Addendum #1

March 10, 2023

Genoa Bank
Fremont Branch
1701 West State Street
Fremont, OH 43420
DAP Project No. 22019

This Addendum supplements and amends the original Drawings and Specifications dated February 16, 2023. It shall be taken into account in preparing bids, and shall become a part of the contract documents. This Addendum shall be receipted on the Bid Form.

DATE:	JAN 2023
DRAWN BY:	DRF
JOB No.:	22-2328
SCALE:	1"= 20'
SHEET	C-6

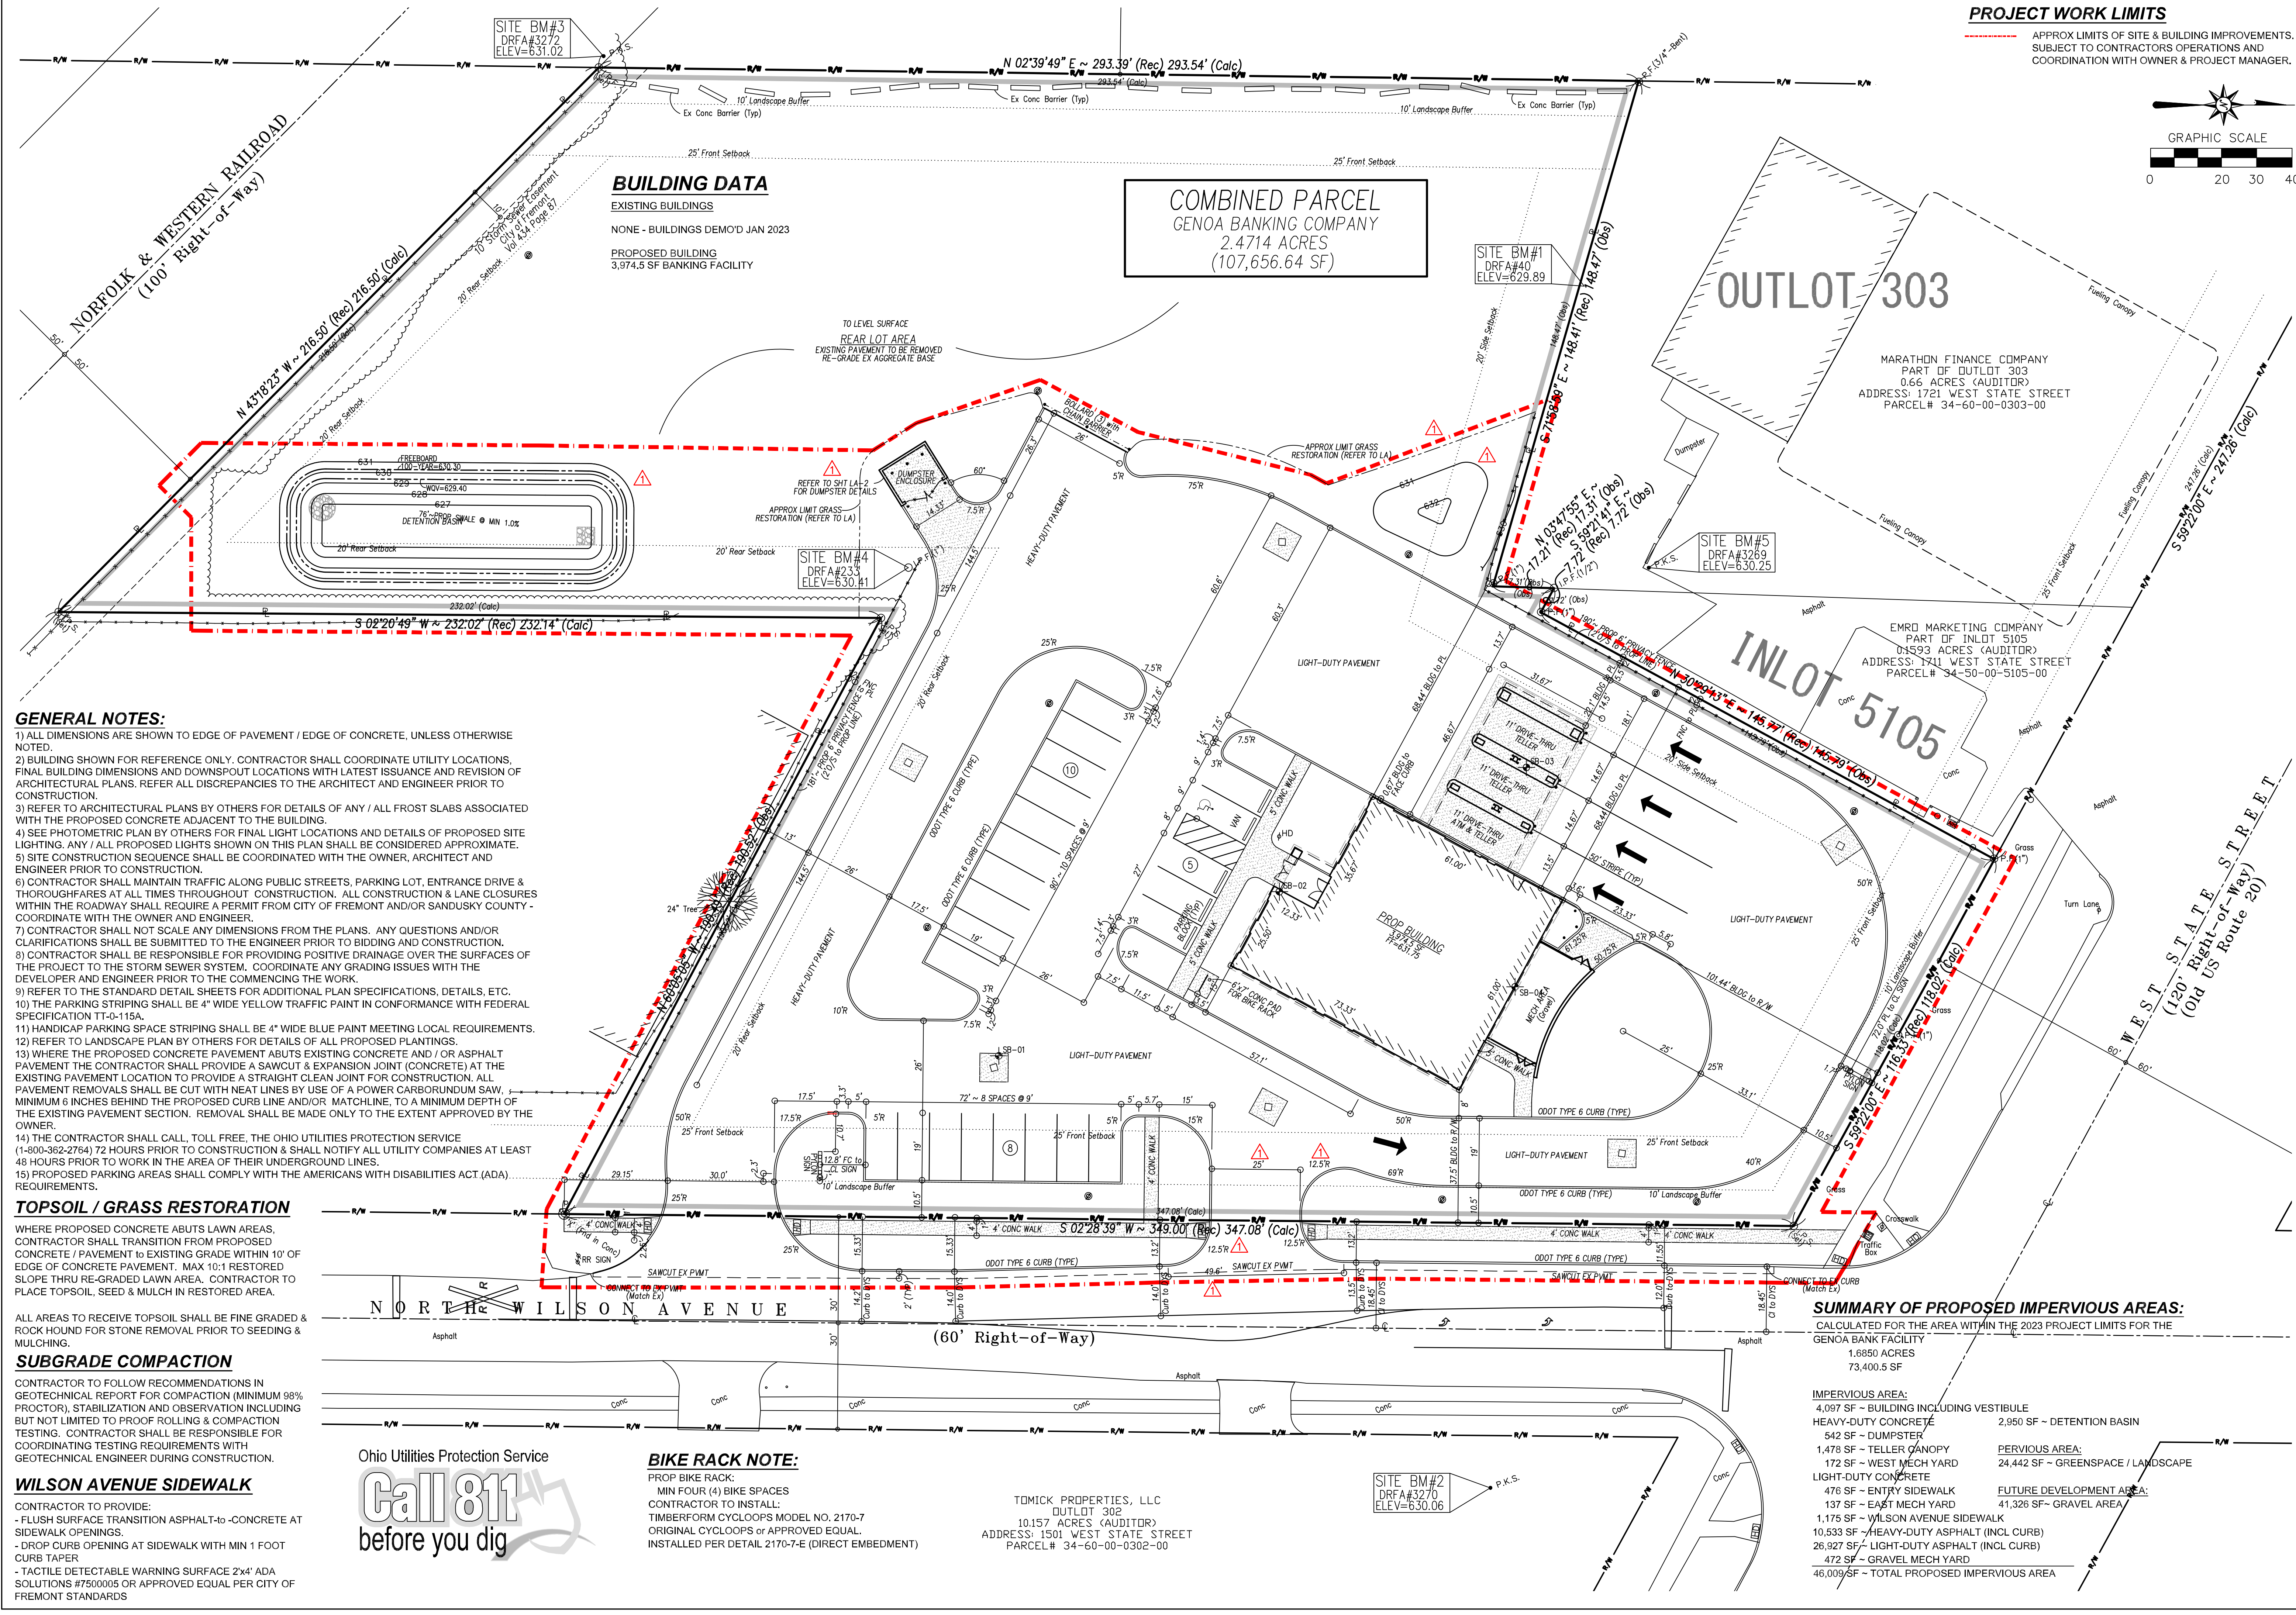
- Sheet C-6 & C-7 – reduce the North drive to Wilson Avenue from 26.3' to 25' wide including adjusting flare radii to 12.5' to Wilson Avenue curb.
- Sheet C-8 – storm sewer ST#1 to ST#2 revised to 12" pipe.
- Sheet C-8 – storm sewer ST#2 to ST#3 revised to 12" pipe.
- Sheet C-8 – storm sewer ST#5 to ST#6 revised to 12" pipe.
- Sheet C-8 – storm sewer ST#7 to ST#8 reduced pipe length from 101 lf to 90 lf.
- Sheet C-8 – revised high water/WQV elevations per drainage calculations.
- Sheet C-8 – revised ST#9 outlet control structure per drainage calculations.
- Sheet C-7 & C-8 – increase the N-S length of the detention basin by 14'. No change in width of the basin.
- Sheet C-7 & C-8 – increase the slope of swale in detention basin to 1.0% from inlet to OCS.
- Drainage calculations (to City Engineer) – reduce allowable outlet flow & increased required detention basin storage.

SHEET
C-13

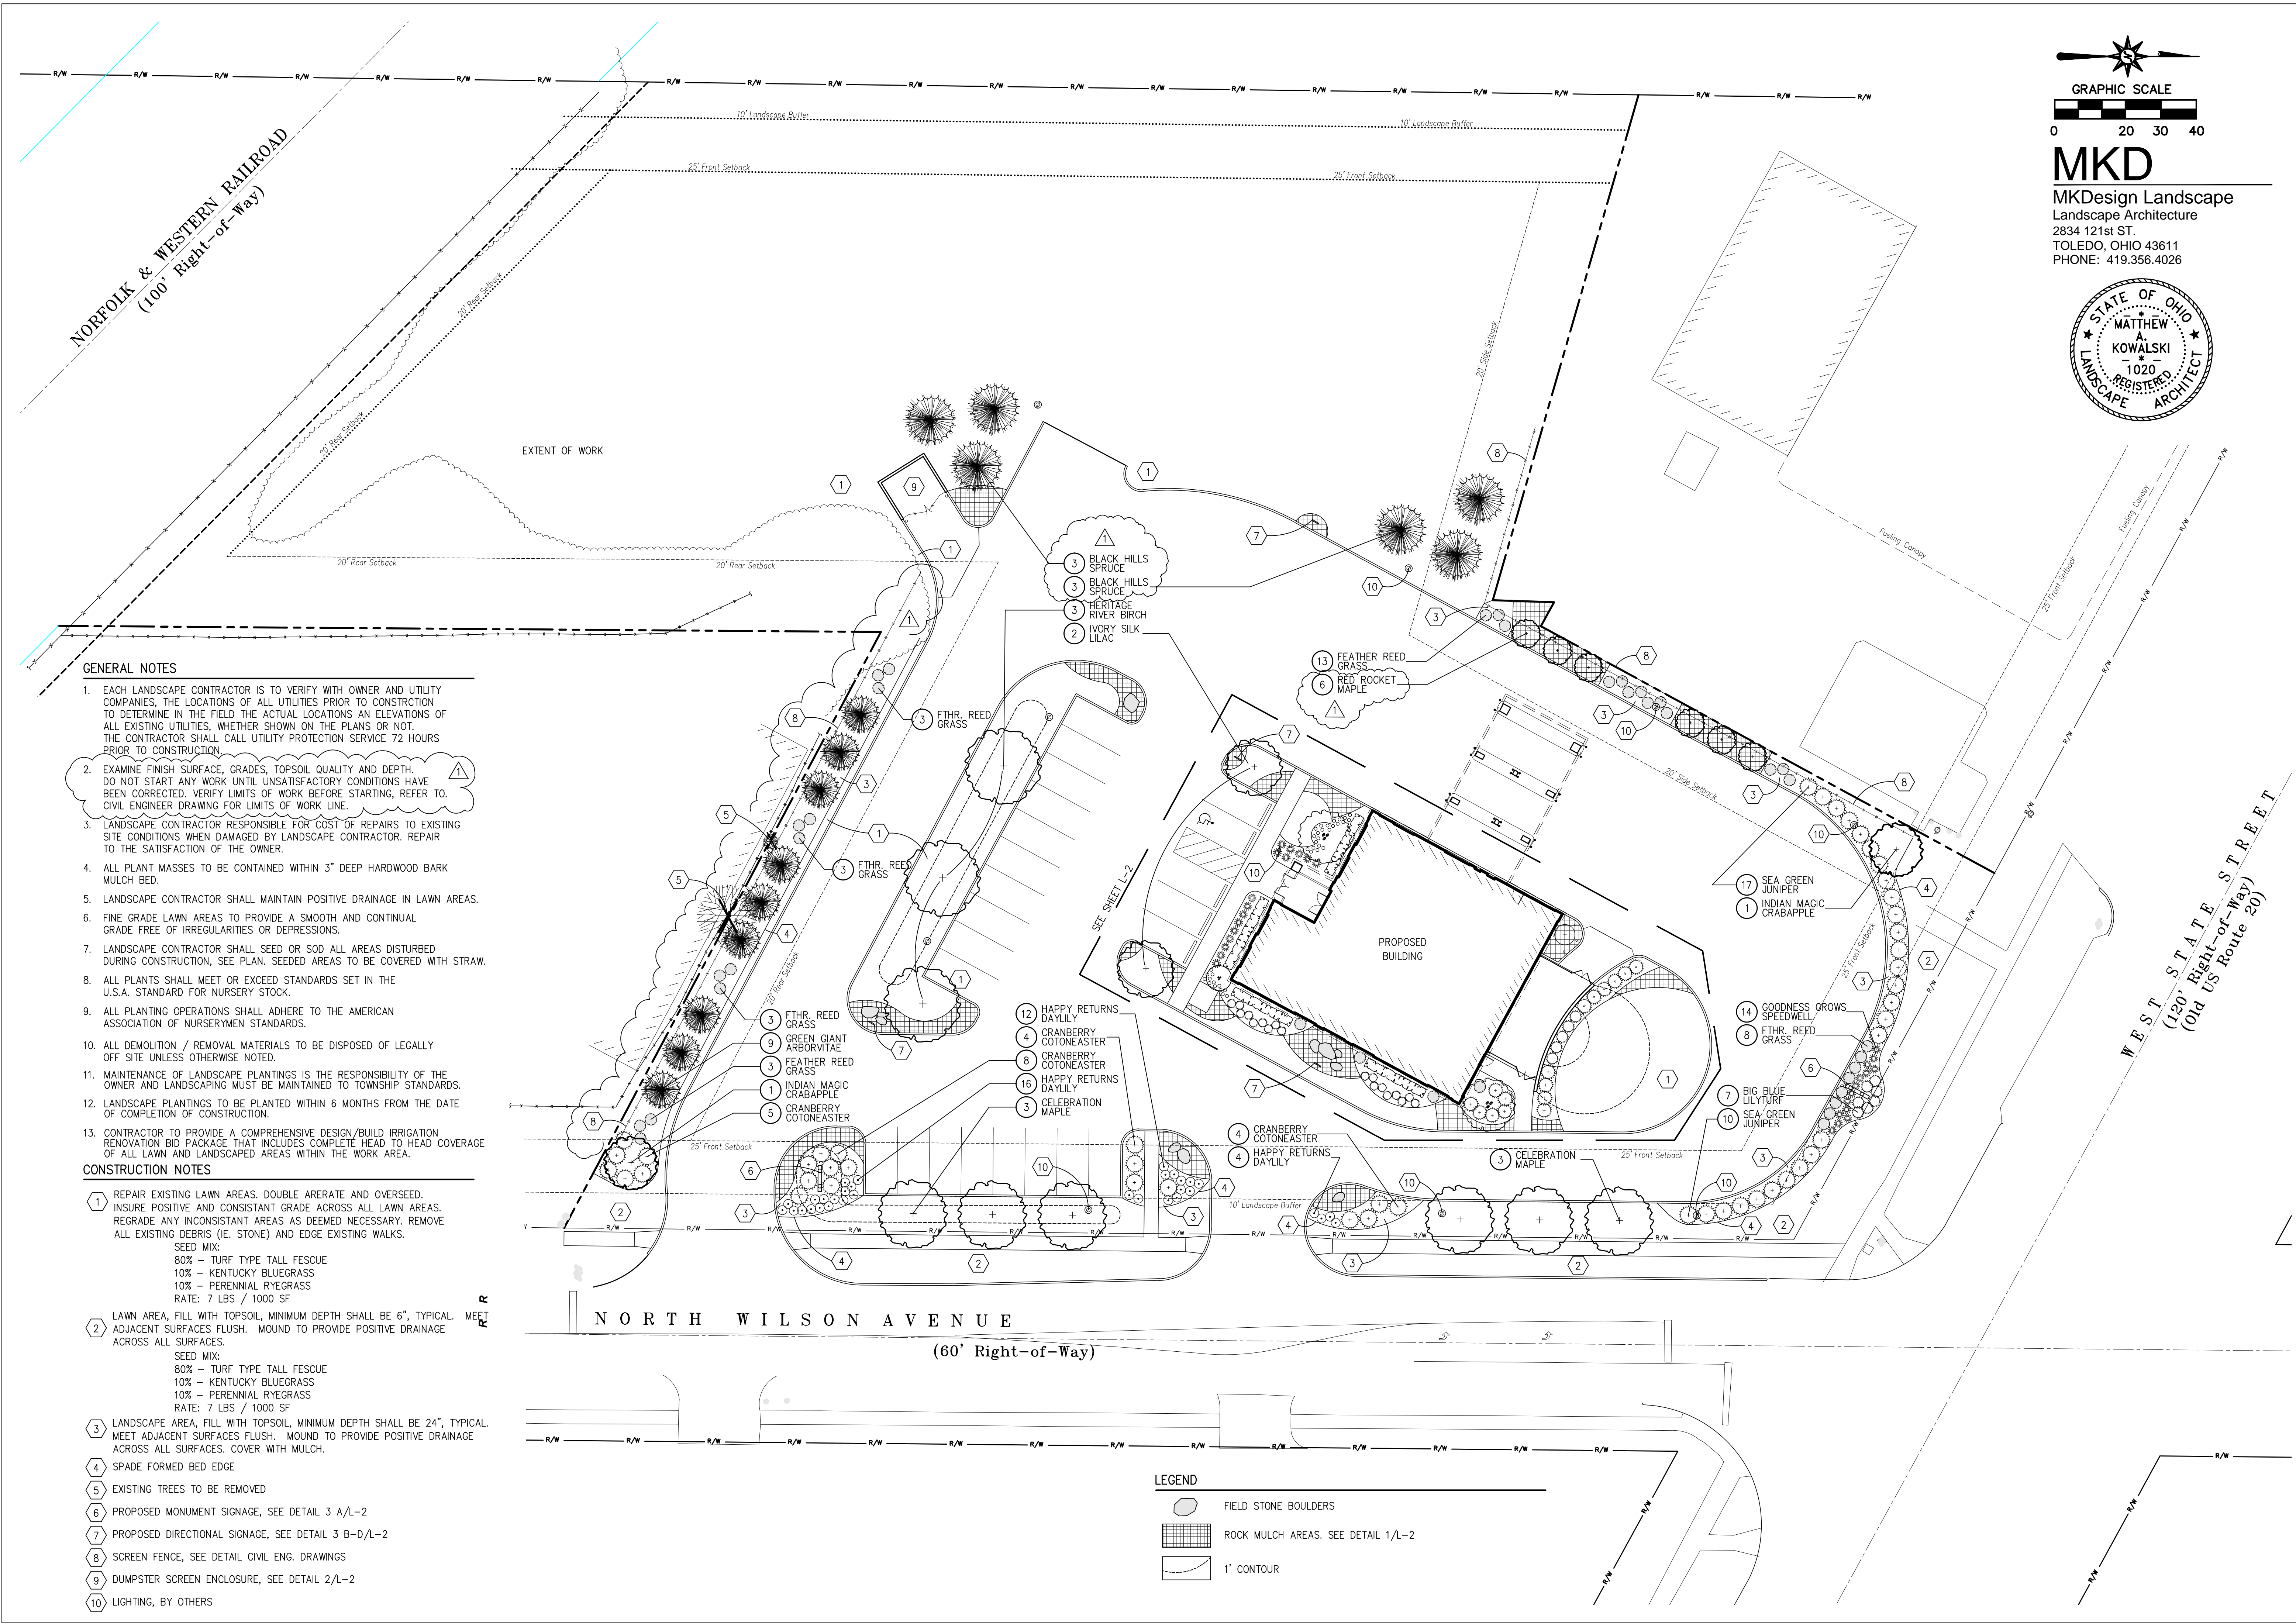
- Sheet C-13 – add ADA parking sign detail

- Sheet C-13 - Revise Bollard Count Note.
- The bollard count is as follows:
 - Dumpster Enclosure: 5 bollards
 - Chain Access Barrier: 3 bollards w/ Chain Barrier
 - Teller Drive-thru: 6 bollards
 - Mech Yard Access Drive: 3 bollards

SHEET
L-1

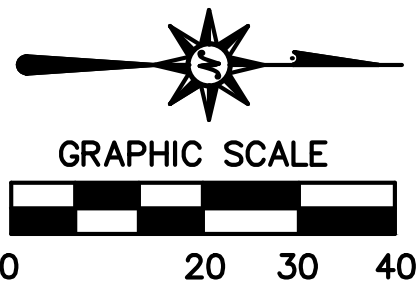
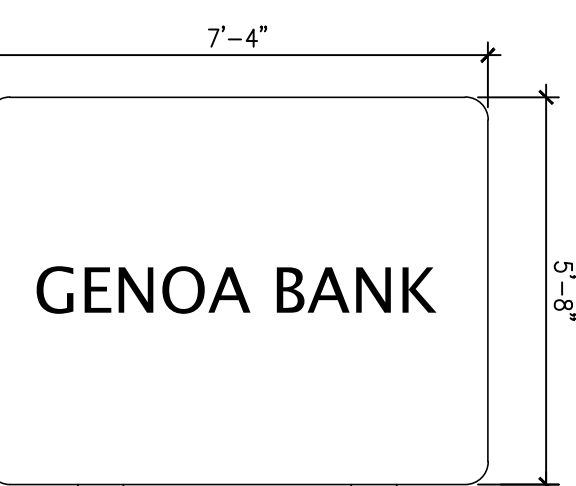
Item 2: Sheet L-1, General Notes No. 2: Add comment regarding coordination with Civil Drawings for limits of work line.

Item 7: Add legend with hatch patterns for field stone, rock mulch areas, and contour lines.
